WESTBROOK PLANNING BOARD
Tuesday, January 18, 2022, 7:00 P.M.
Westbrook Middle School – Performing Arts Center
471 Stroudwater Street

TO: Planning Board
FROM: Jennie P. Franceschi, City Planner & Rebecca Spitella, Assoc. Planner
Cc: Plan Review Team

RE: January 18, 2022, Planning Board Meeting

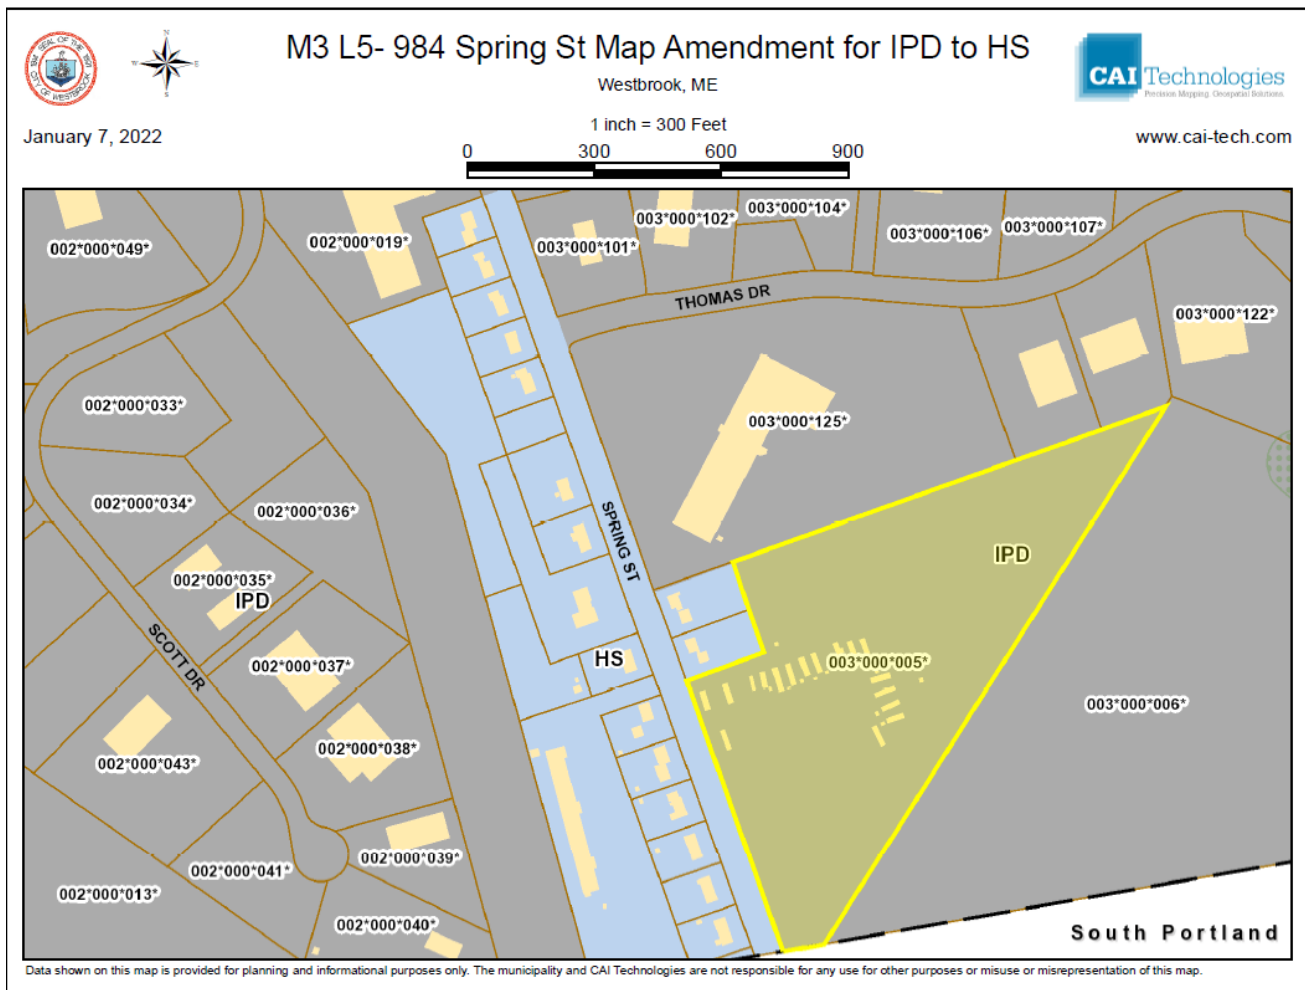
Previous development attempts on the 984 Spring Street parcel have not been successful due to the presence of difficult soils conditions on site that would be a challenge for the larger industrial and high intensity uses that are encouraged in the Industrial Park District. Due to this, a lower intensity use is and will continue to be the type of development this parcel can support. Highway Services District, while similar in the commercial uses of the Industrial Park District, provides greater variety of uses requiring a smaller building footprint, thus more compatible for the subject site.

Further, the Highway Services District is intended to provide a gateway commercial corridor. Currently, Highway Services includes only the parcels on the Westerly side of Spring Street. Staff finds the rezoning of the 984 Spring Street parcel to HS achieves the balance along Spring St and could provide the Gateway feel that the Highway Services District was intended to create. (See below Map for location)

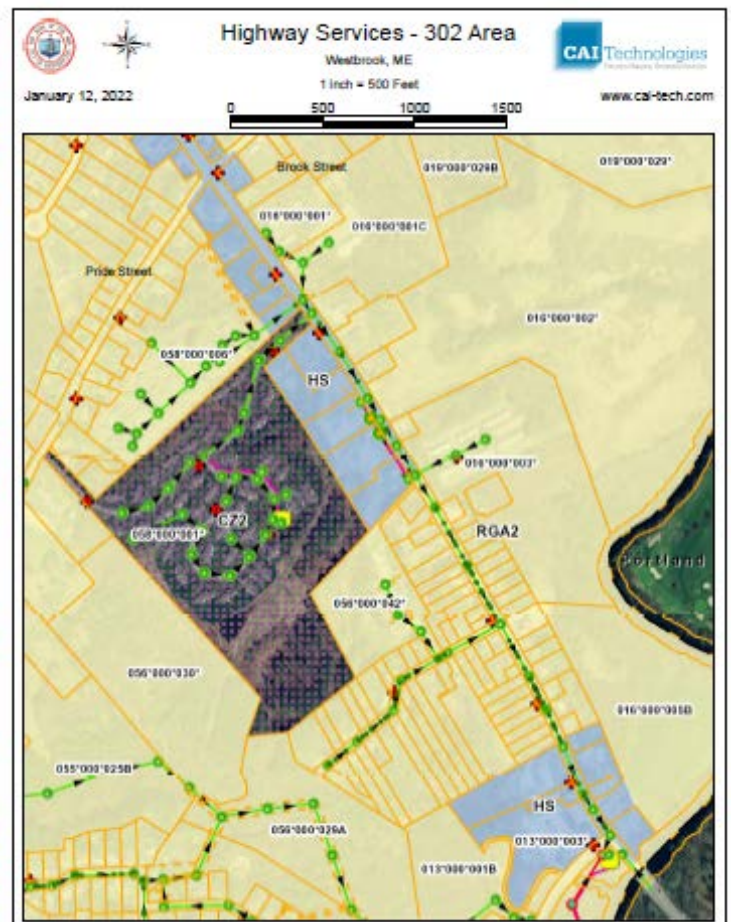
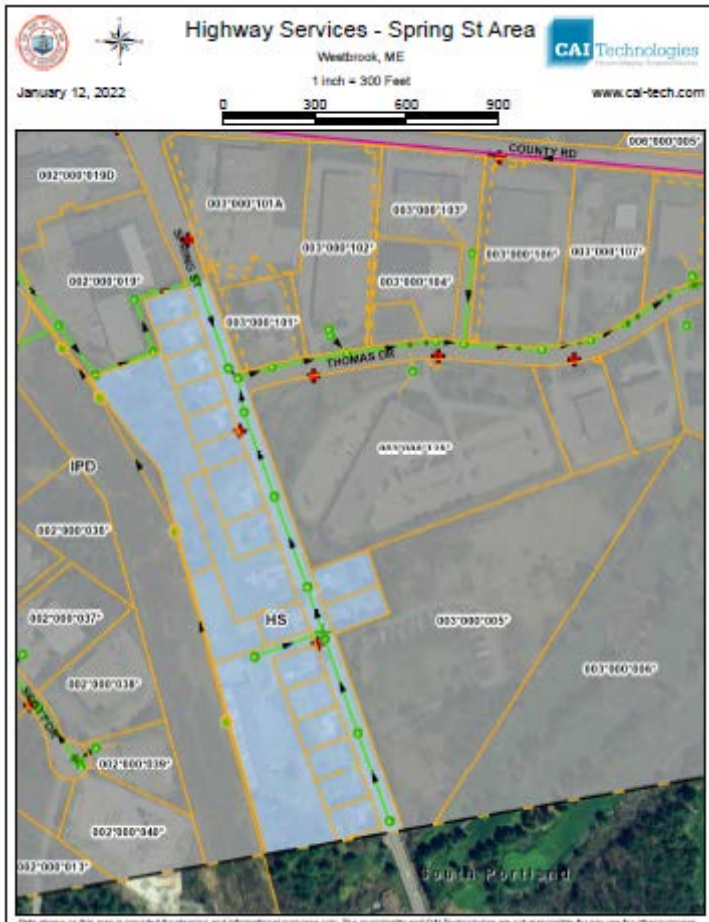
In looking at the Zoning Map, it is not the intention or goal of the Comprehensive Plan to encourage large-scale commercial residential growth in areas of the City that are not serviced by City Services. Therefore, Staff is recommending a provision where Multi-family Dwellings are permitted within the Highway Services district only on parcels that are or will be served by public water and sewer. Those areas are currently identified as Spring Street at the South Portland Municipal Line and Route 302 - Approximately 650’ southerly of Pride/Brook St intersection and toward Portland Municipal Line. (See below maps for reference of areas.)

The Ordinance amendment needs to include a density factor with the proposal of residential use; therefore, Staff is recommending a residential density of 1 unit/2,500 square feet, which is consistent with the Residential Density Factor of the Gateway Commercial District.
